City of Alexandria, Virginia

MEMORANDUM

SUBJECT: CONCEPT REVIEW OF 1604-1614 KING STREET
BAR CASE # 2023-00376

Figure 5: North elevation of option including arched openings and strong horizontal bands

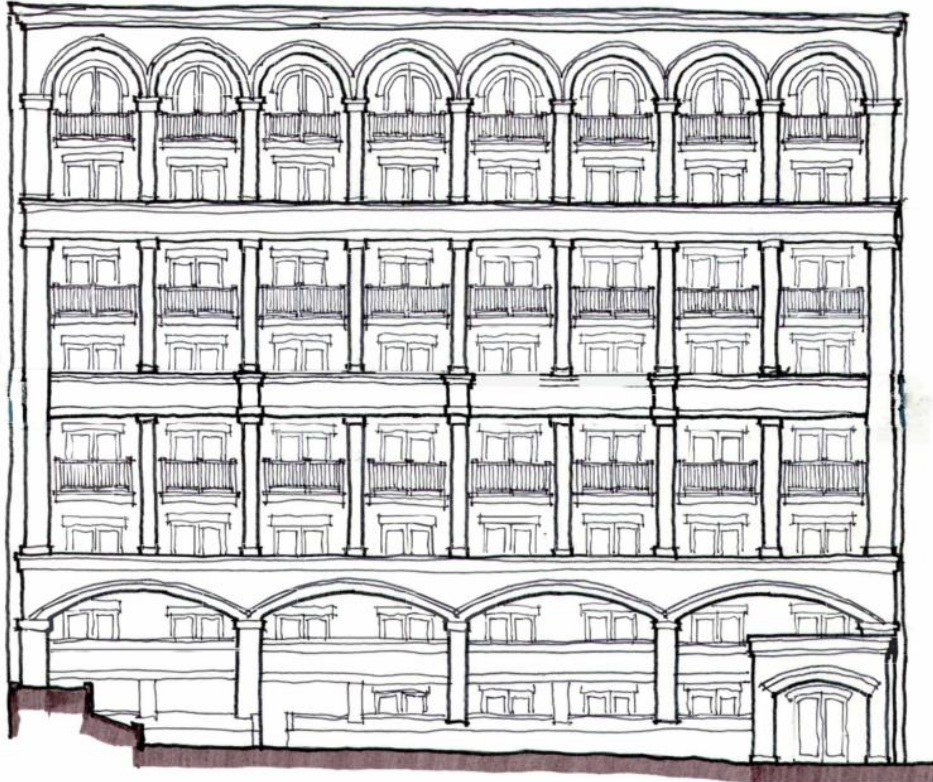
The current proposal for the multi-family building differs from previous versions, including two options that are more traditional than some of the previous options. The first option includes eight equal bays of two-story openings starting at the third floor with a strong horizontal band at the fifth and eighth floors. This strong horizontal band creates a solid railing to recessed balconies. At the other levels, a railing extends across the bay, enclosing the recessed balcony. Separating the bays are two story columns with decorative bases and capitals. At the top of each bay is an arched opening (Figure 6).

It should be noted that the provided north elevations show the building as seen from the internal courtyard, not from King Street. Given the height of the existing townhouses, the lower section of the multi-story building will be hidden from view (Figure 5).

- The variation in horizontal expressions included in the first option is more successful than the open railings in the second option.
- In both options, the applicant should consider some variation in the width of the bays and the vertical components. Groupings of two bays will establish a rhythm that is more complex than the repetitive single bay pattern currently shown.
- In the first option, the vertical elements are decorative columns that span two stories. In the second option, these elements are more simple vertical piers. The vertical elements

- It is unclear what is happening at the base of the second option, but the base of the first option is an opportunity to reflect the variation in pier and bay widths described above. Thicker vertical elements that align with the spring point of each arch would give a hierarchy to the overall composition.

Staff does not support either of the proposed designs specifically but does endorse the parti as described above and recommends that the applicant return to the Board with a revised design that addresses the design principles outlined in the *Design Guidelines*. Specific comments to be addressed include the following:

Figure 6: North elevation of option including railings at each recessed balcony

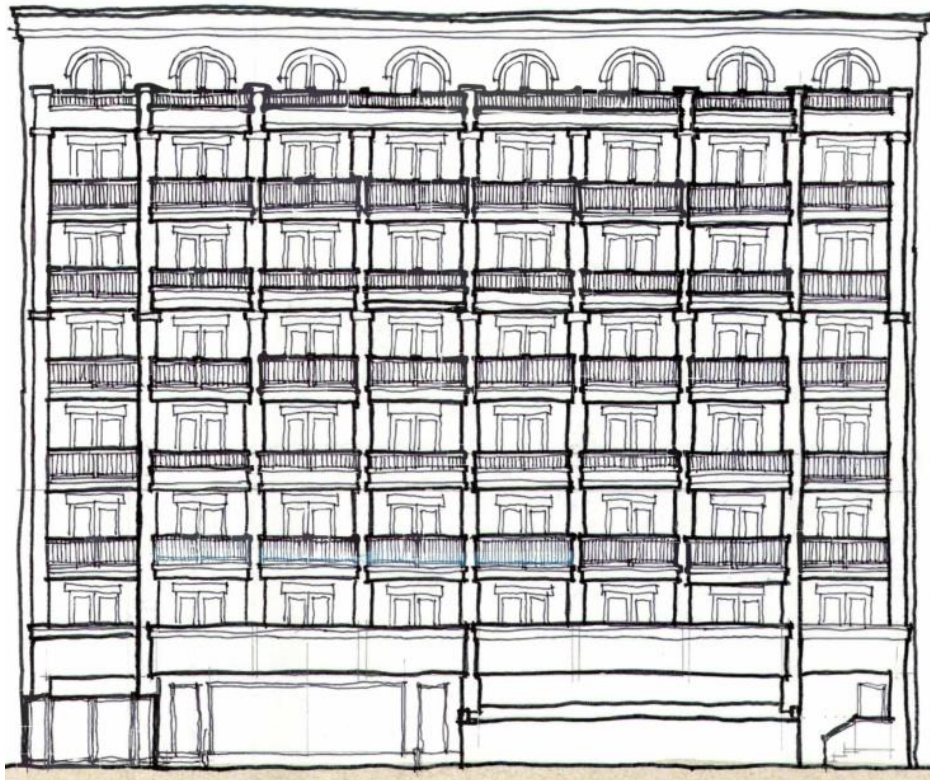
The second option for the west elevation similarly includes eight equal bays separated by a vertical pier. In this option, each floor between the second and seventh floors are the same and include railings extending between the vertical piers. The eighth floor is set back from the others and includes a terrace with railings spanning between piers aligned with those below. At this level, the double doors leading to the terrace include an arched opening (Figure 7). The submission includes one option for the south, east, and west elevations that is similar to the second option.

- The recessed upper floor in the second option is another opportunity to reinforce the design parti. If this recess aligns with the inner wall below, the architectural language could be similar, allowing the inner wall to extend above the outer framework.
